PROCESS CHANGE NOTICE
 PRODUCT CHANGE NOTICE
**MAXIM INTEGRATED HEREBY ISSUES NOTIFICATION OF CHANGE
 THAT MAY AFFECT THE FOLLOWING CATEGORIES:**

Ordering P/N: (See PN listing XLS in PCN ZIP file)

CHANGE FROM: VINL: max 0.8V

CHANGE TO: VINL: max 1V

Functional Diagram

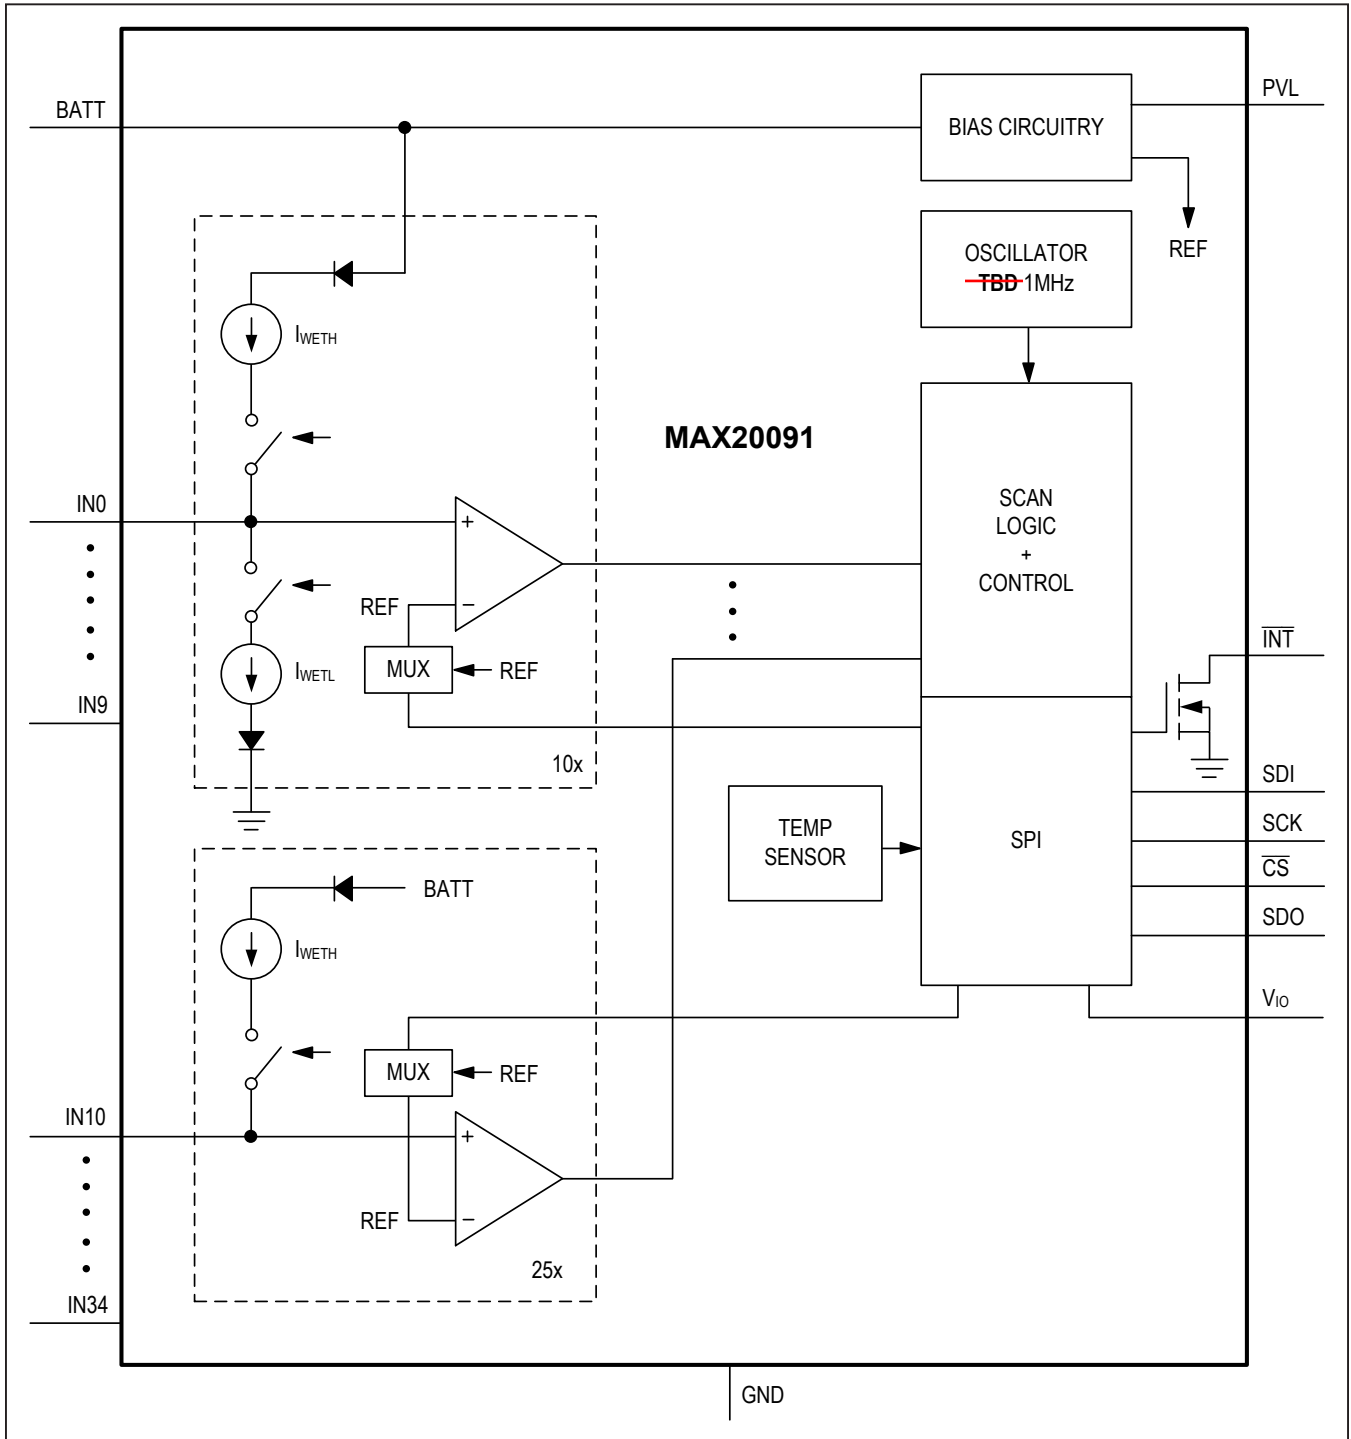
In polling mode CS must be maintained high in order to ensure correct operation of the INT output. If needed the PVL output can be used as the pullup power.
